Channel Stability Problems, Iao Stream, Maui, Hawaii

**U.S. Army Engineer Committee on Channel Stabilization
Report of the 64th Meeting—September 1999**

The 64th meeting of the Engineer Committee on Channel Stabilization (CCS) was held at the request of the U.S. Army Engineer District, Honolulu, on 14-16 September 1999. The Committee convened to review and offer guidance on design modifications to the Federally-designed and constructed Iao Stream Flood Control Channel Project located near Wailuku County in Maui, Hawaii.

Figure 1. Cross section of armored channel adjacent to existing levee

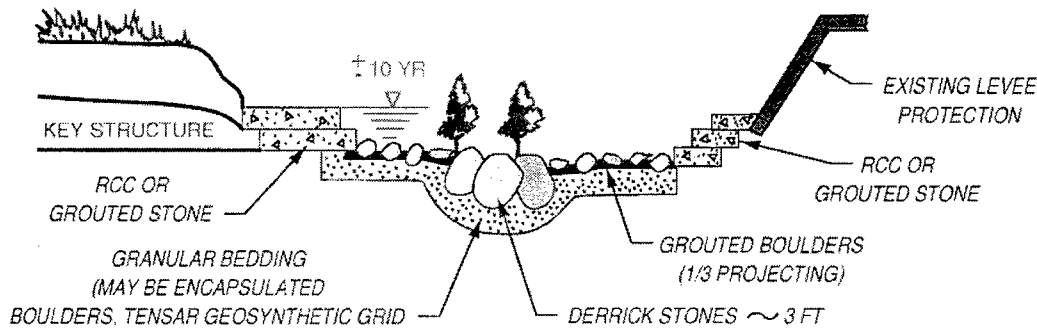
Key structures would prevent flanking at high flood flows. Cross channel grade control sills should also be included as a safety feature. Keys and grade control should be spaced between 200 to 500 ft.

Figure 3. Profile of threshold channel design with slope reduced by drop structures

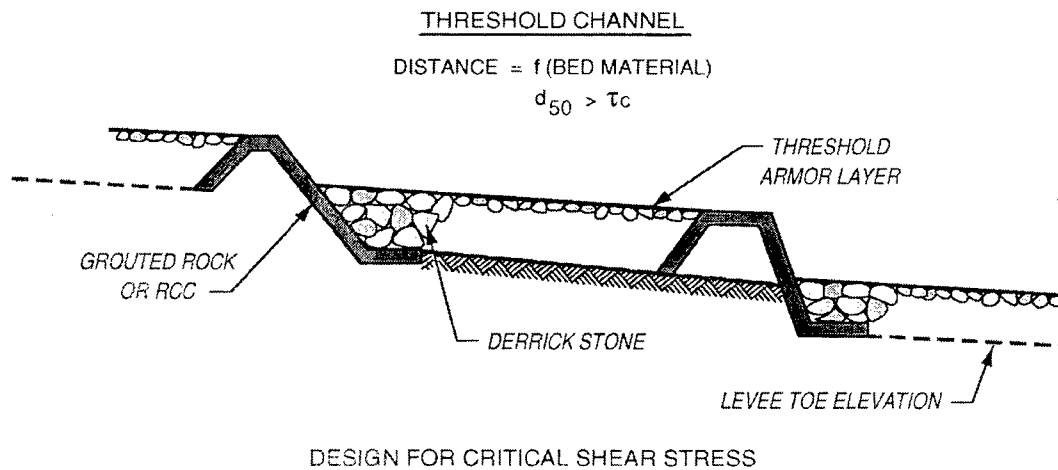
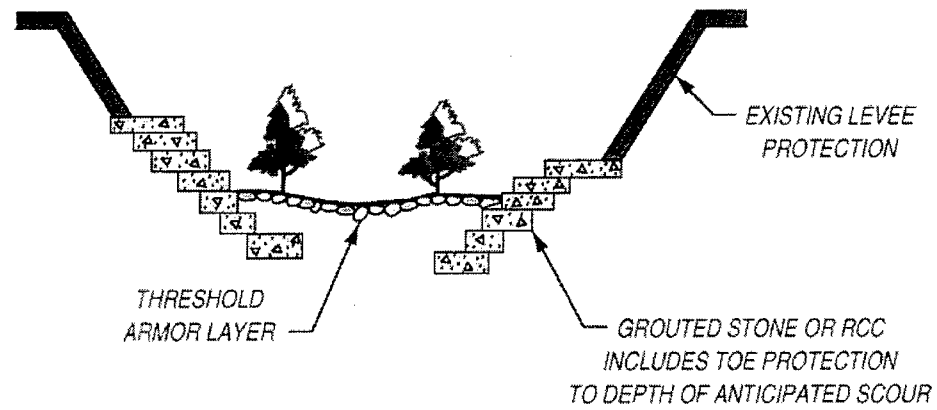
NOTE: TOE PROTECTION WITHOUT DROP STRUCTURES
REJECTED BECAUSE OF UNCERTAINTY

Figure 8. Bank protection alternative near Sta 43+00

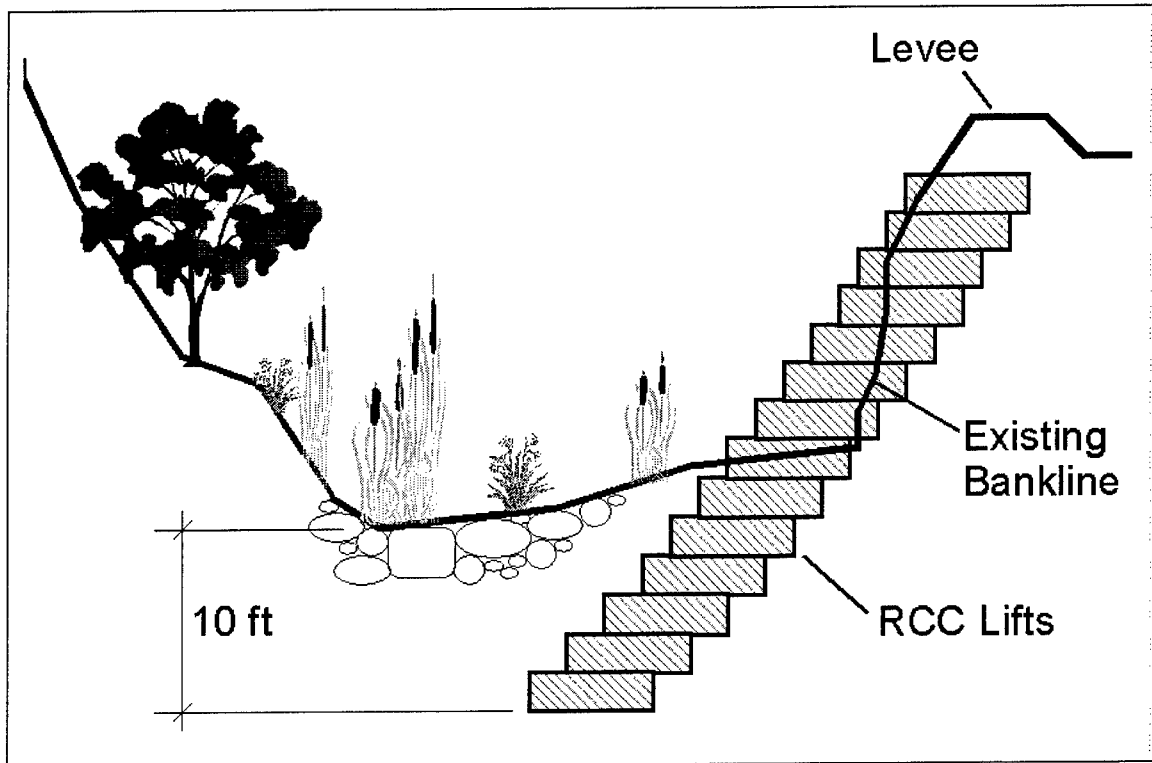
Bank protection at Sta 43+00. During the field trip, one of the more spectacular sights included the eroding bank near Sta 43+00. It appears that the sideslope of the right levee (Levee B) has eroded by as much as about 15 to 20 ft (or more) horizontally. I would recommend that POH give this reach top priority since failure of the levee is imminent. I envision that the roller-compacted concrete (RCC) sideslope discussed for the channel alternative be constructed along the right bank as soon as possible along this critical reach (Figure 7). Future construction of the channel could be designed to tie into this "early-built" section as necessary. Perhaps, the RCC sideslope could be constructed a minimum of 10 ft below the existing thalweg to prevent undermining, at least for the next few years, while at the same time providing immediate bank protection along this reach. I recommend EM 1110-2-2006 "Roller-compacted concrete" (1992) as a reference for RCC design and placement.
